TRAFFIC IMPACT STUDY

**PROPOSED SPEEDWAY
DEVELOPMENT**

**Located at
Northwest corner
Of
U.S. 23 and Hills-Miller Road
City of Delaware, Ohio**

**Prepared by:
CESO, Inc.
8534 Yankee Street
Dayton, OH 45458**

US 23 LANE WIDTHS

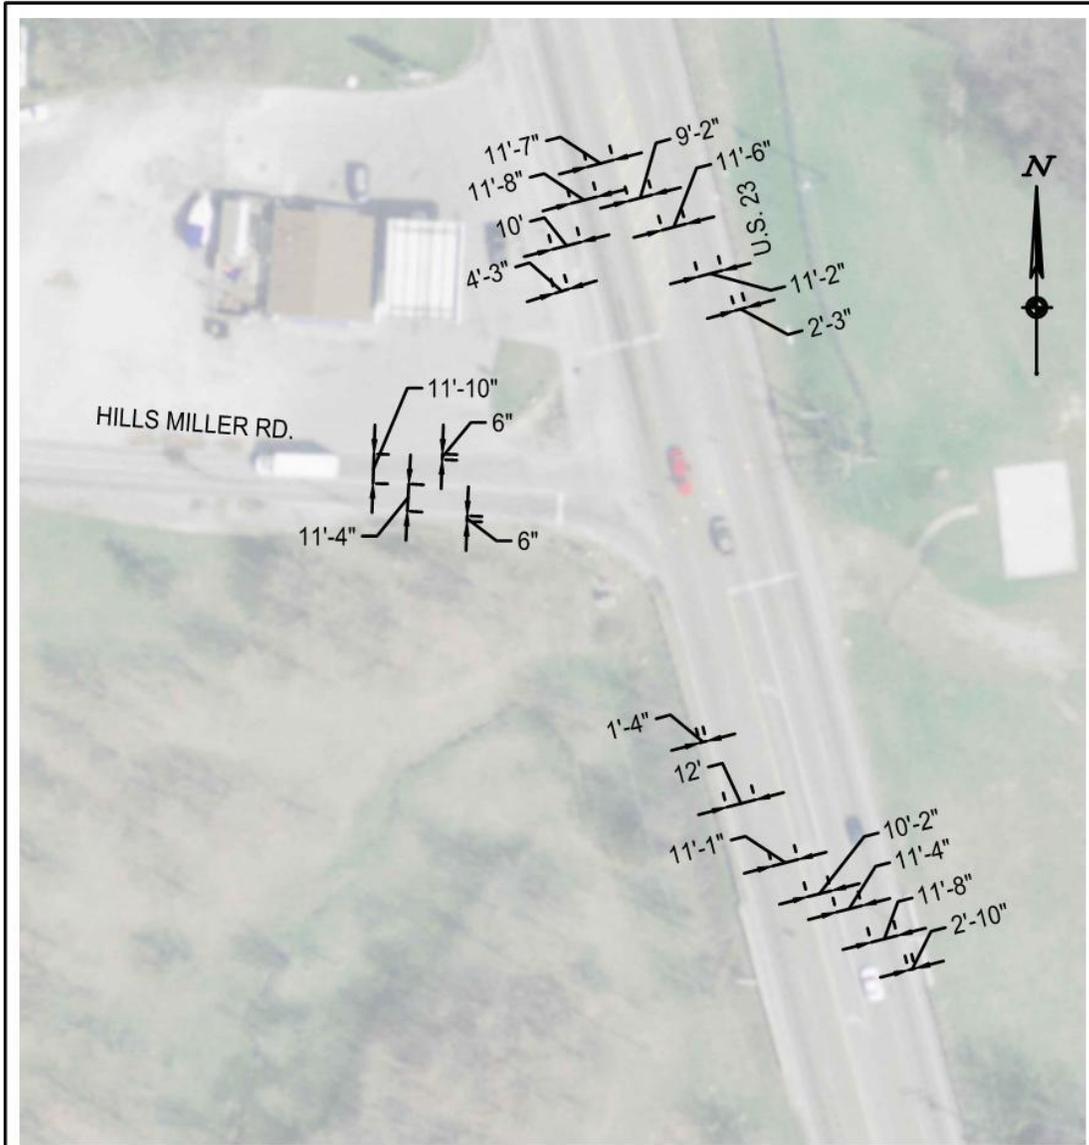
6. Please provide a detailed exhibit of the existing intersection with all current lane and shoulder widths clearly shown. This exhibit could perhaps serve as the base drawing for an autoturn exhibit that shows the encroachment of wider vehicles into other lanes (both turning vehicles and possible sideswipe conditions). The intent is to demonstrate the constraints of the current roadway system to accommodate an even greater volume of trucks and larger vehicles.

RESPONSE: Existing lane width exhibit was modified to show the existing lane and shoulder widths at all three approaches to the US 23 and Hills Miller Road intersection

AM TRIP DISTRIBUTION IN (CARS/HEAVY TRUCKS)

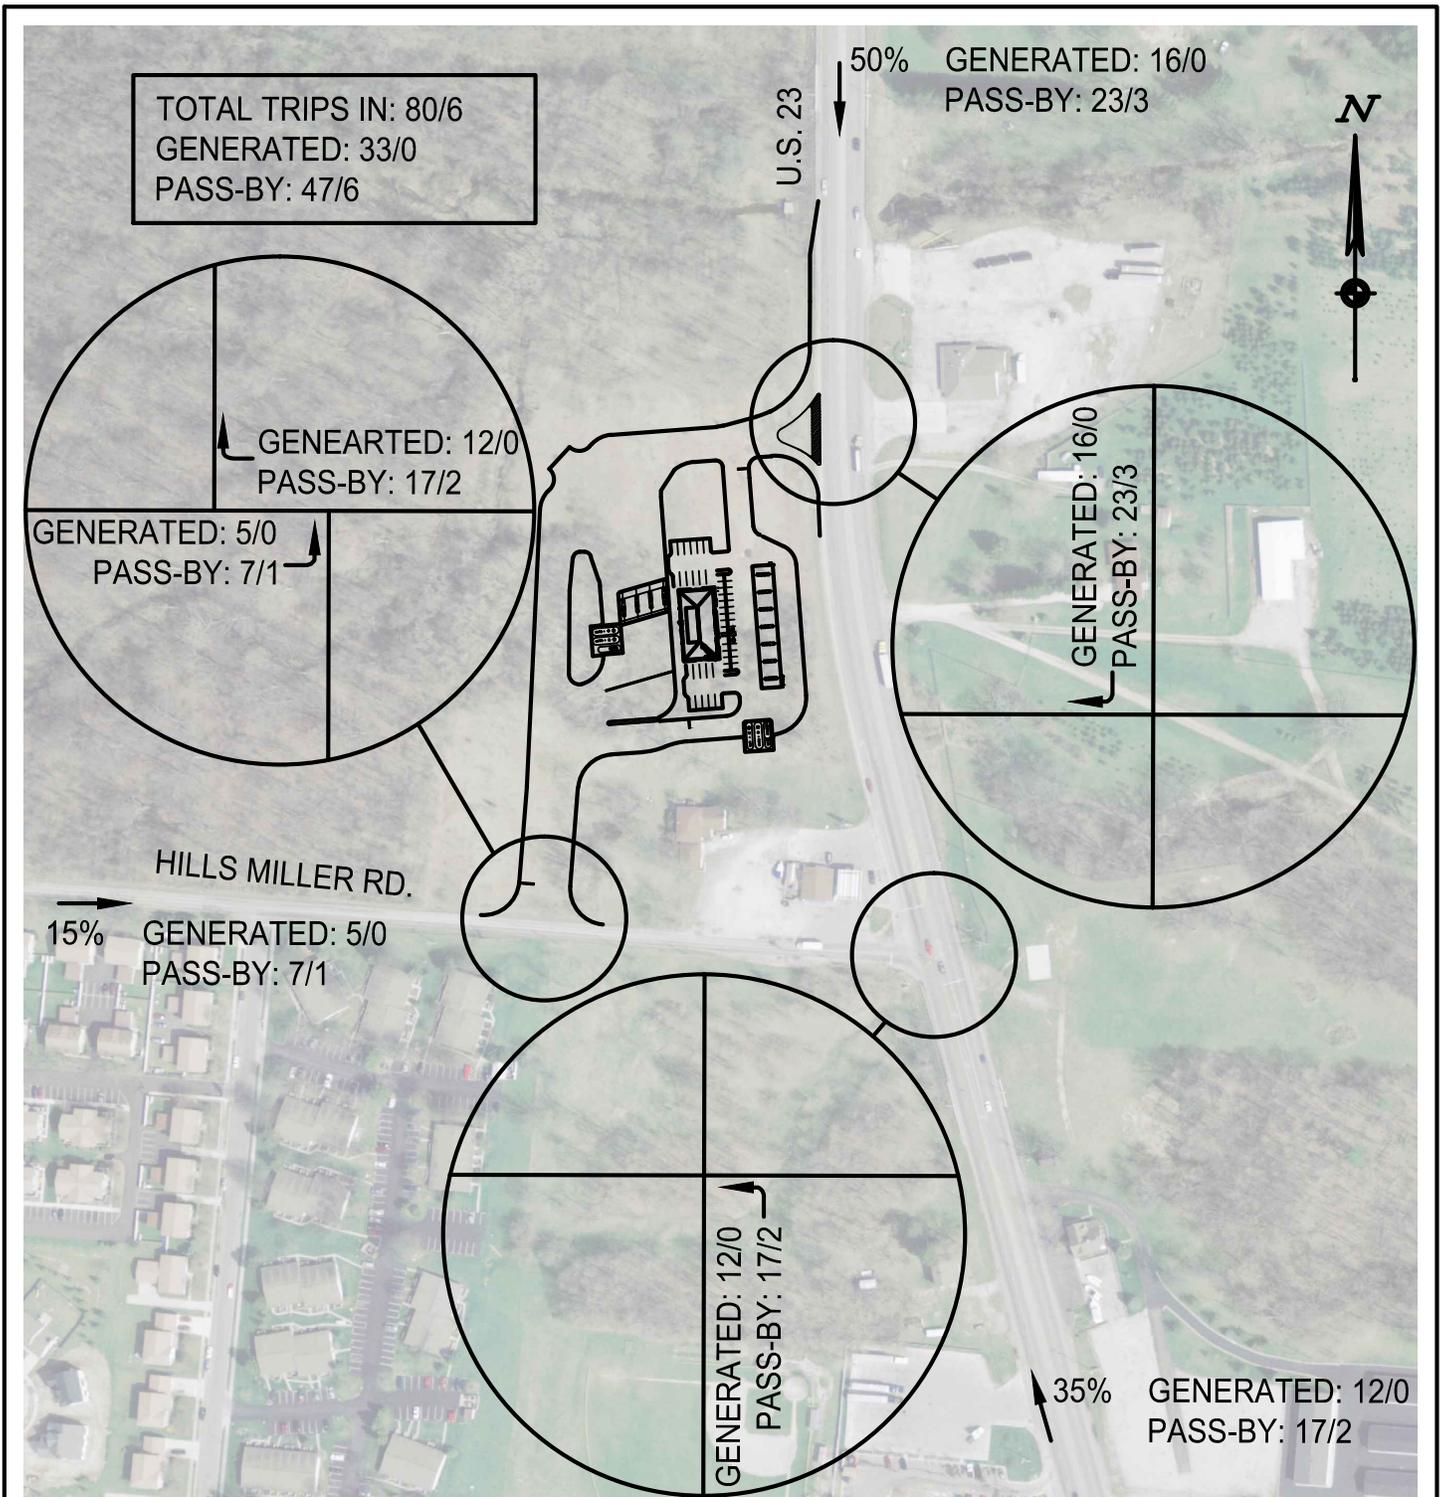
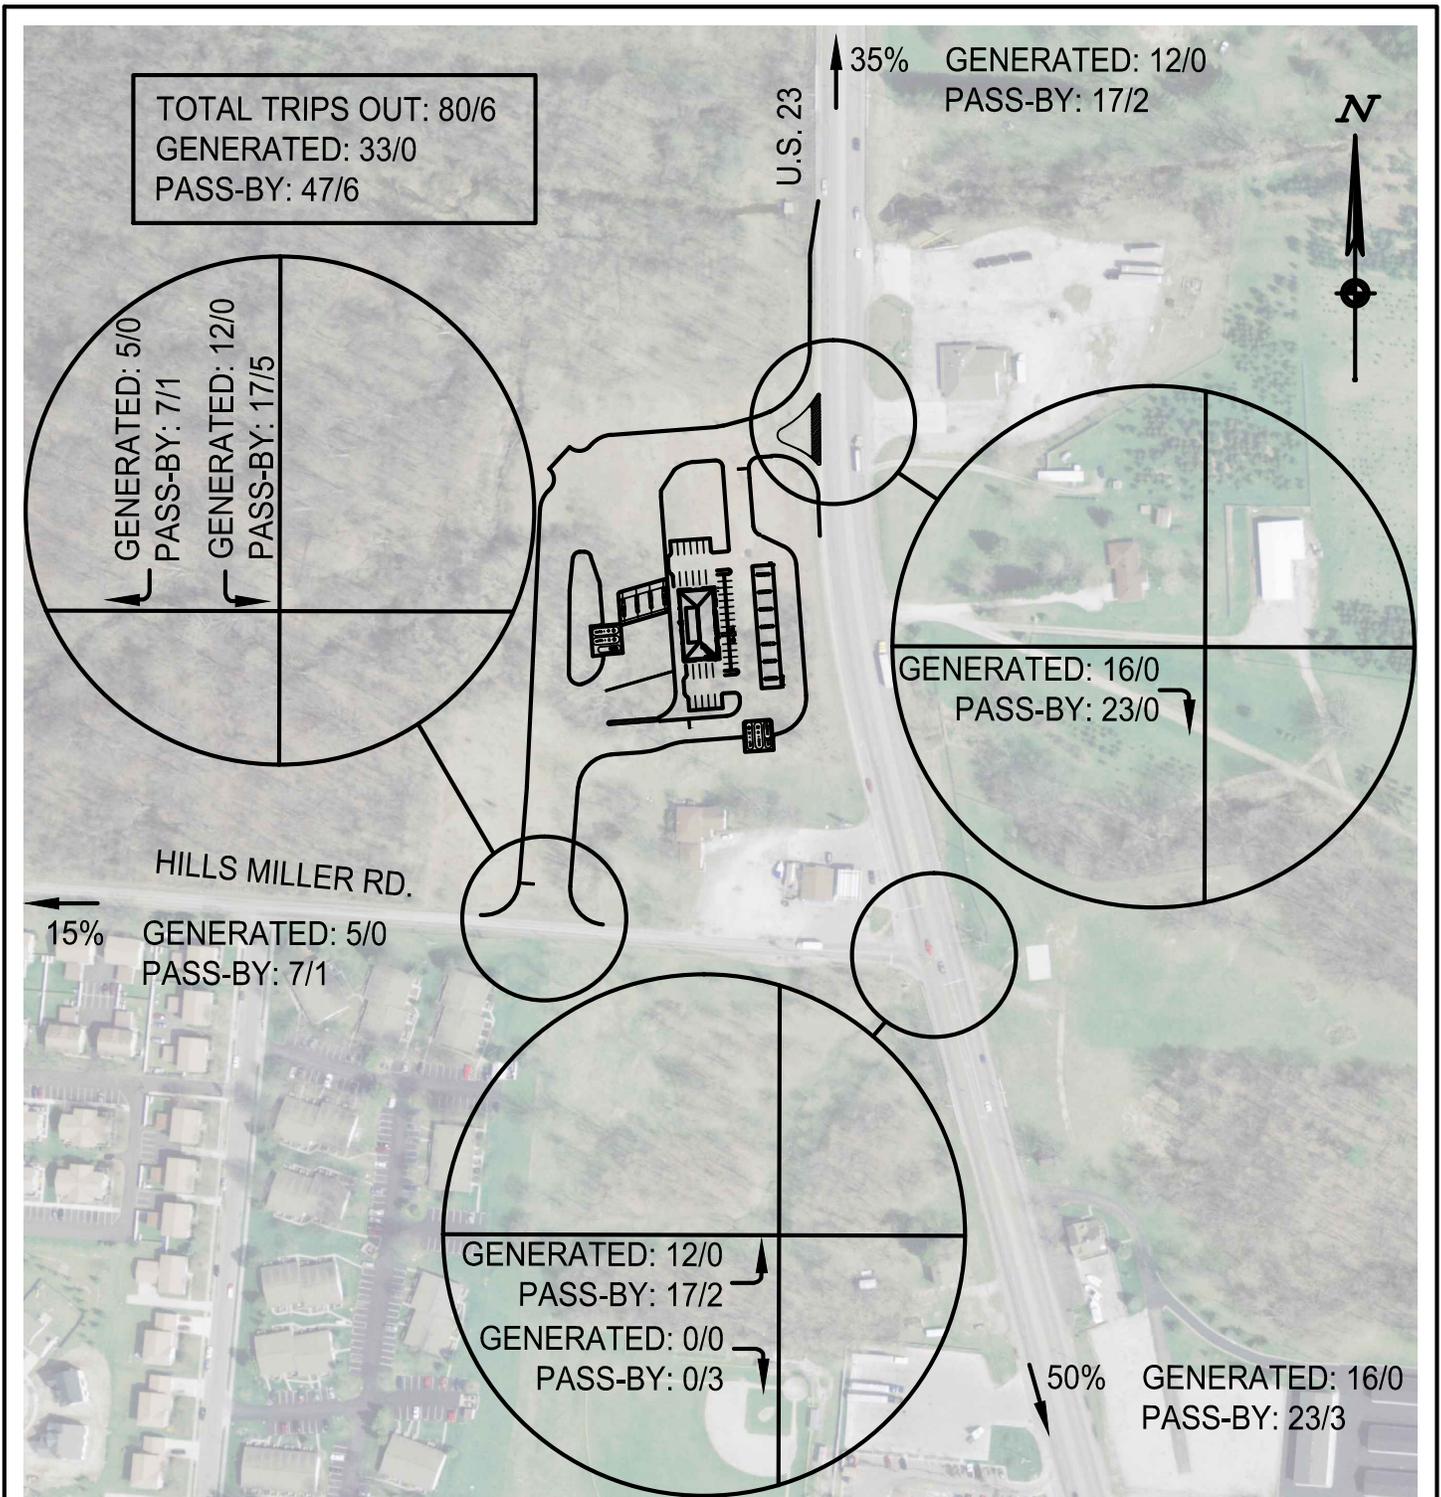
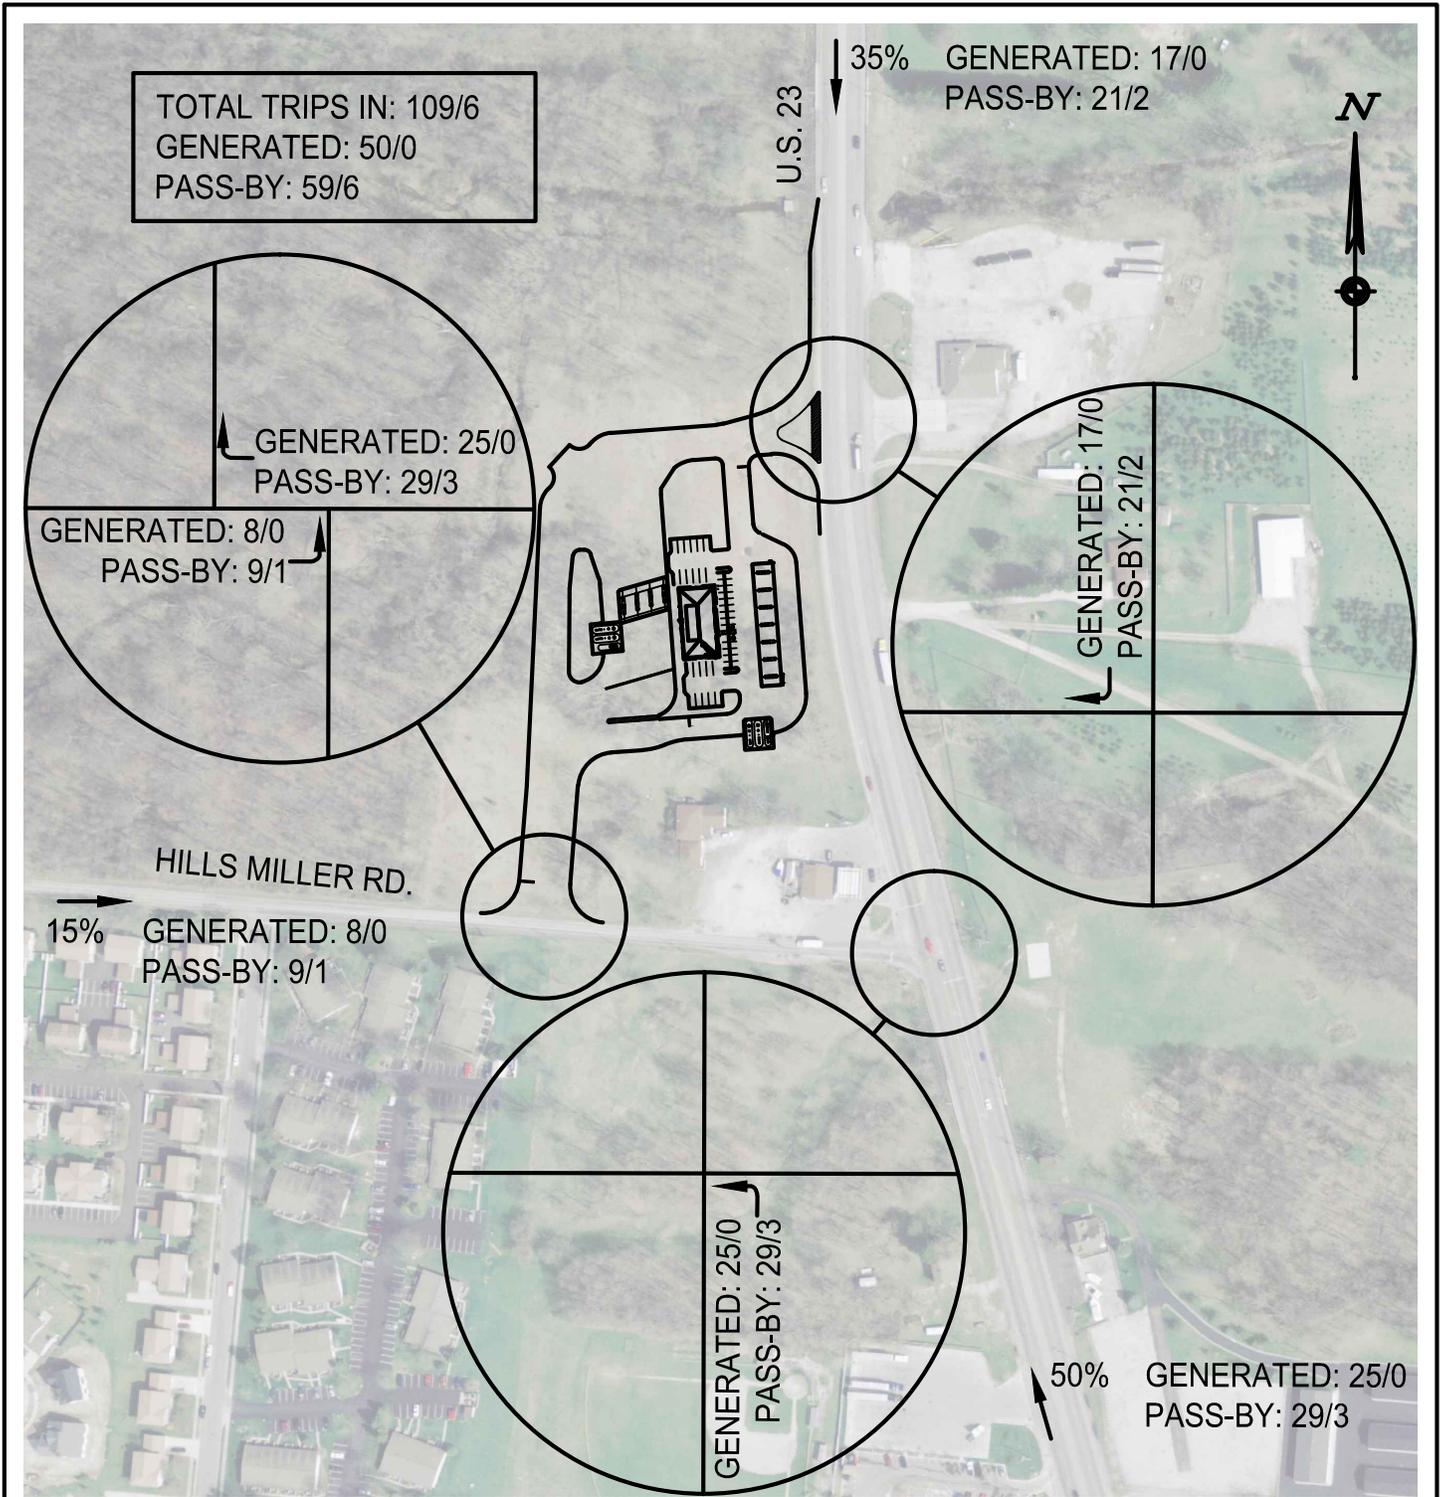
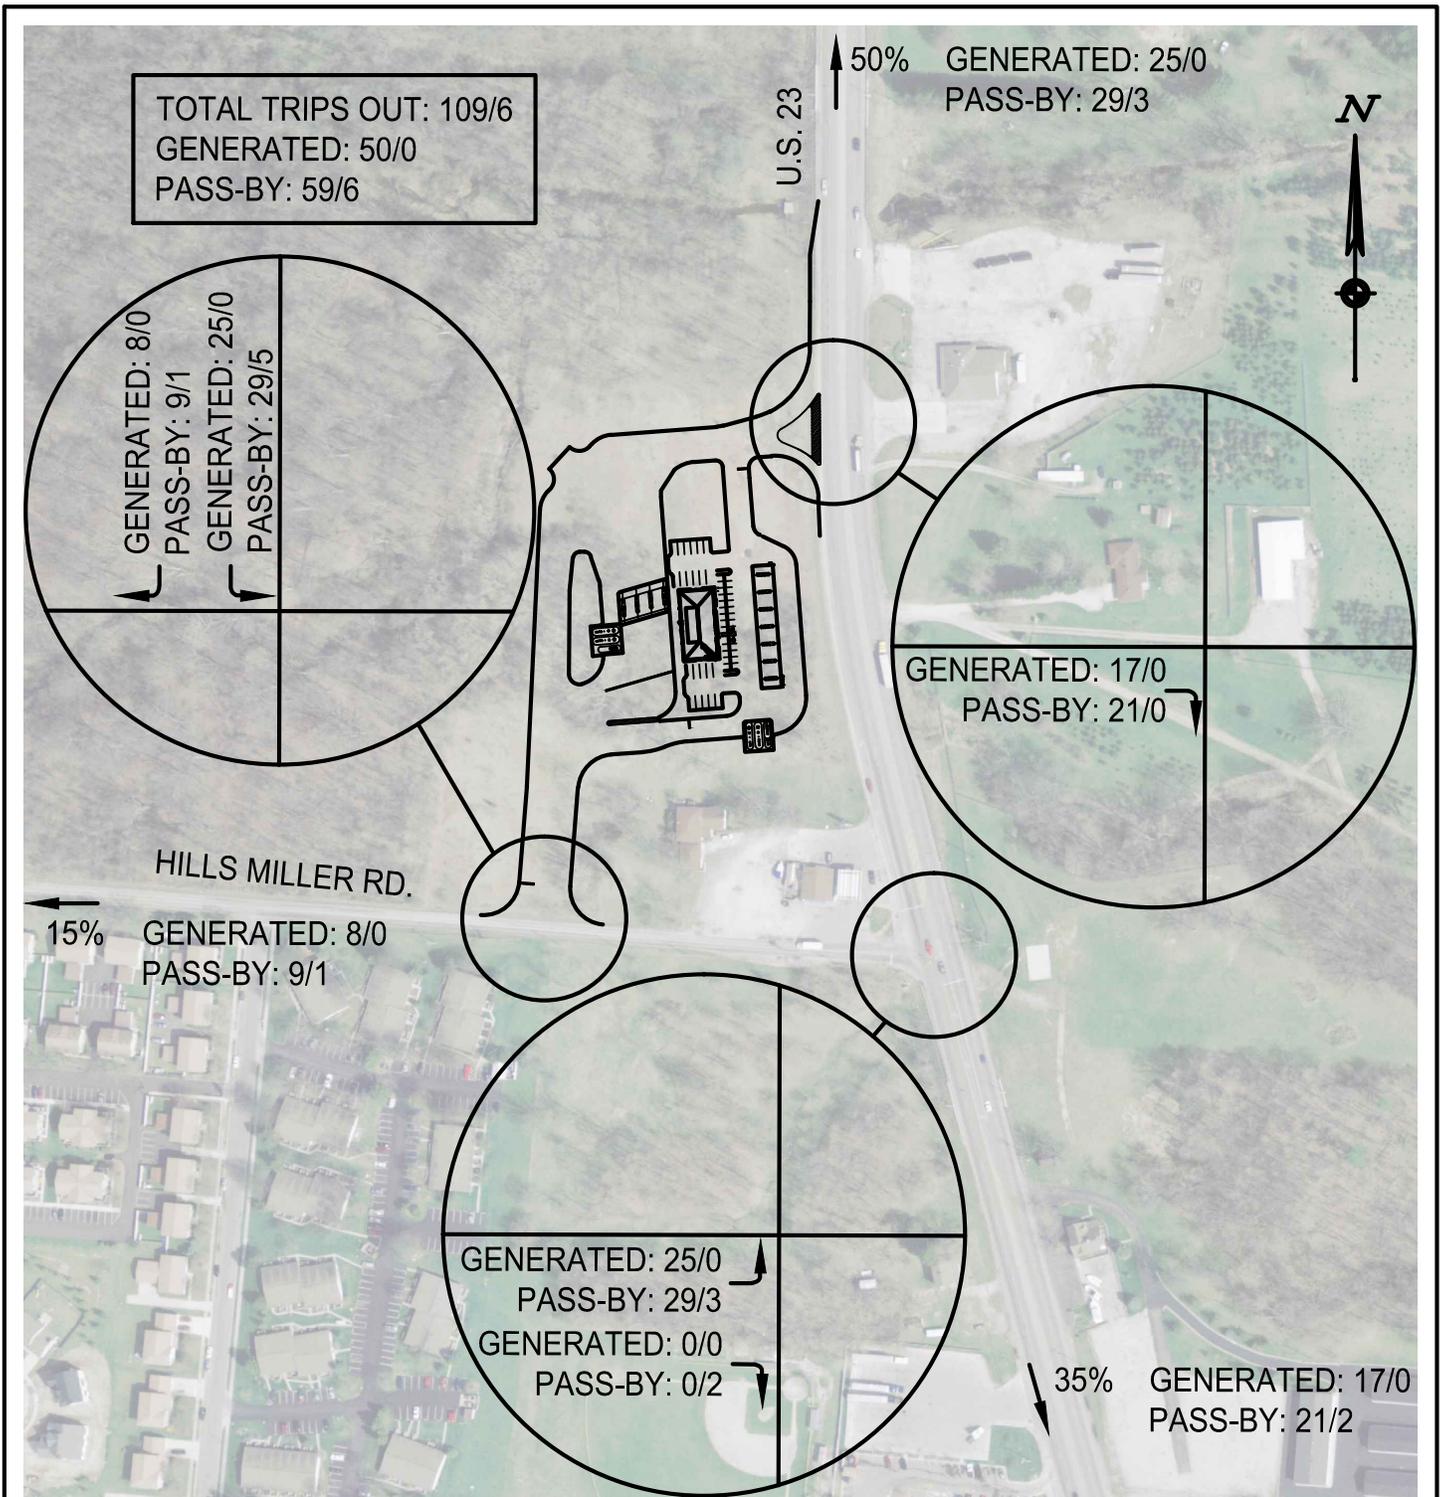
4. It is unclear how the pass-by trips are redistributed into the network. Please clarify and ensure all pass-by trips coming from the site back to the roadway network are accounted for and properly distributed (i.e. pass-by trucks traveling southbound will probably utilize the signal as opposed to RIRO when leaving the site). Please also ensure pass-by trips are not subtracted out of the background traffic more than once.

RESPONSE: Additional figures were added showing the distribution of traffic going in and out of the study area in the AM and PM peak hours. As requested, pass-by trucks traveling southbound were shown as utilizing the signal instead of the RIRO when leaving the site.
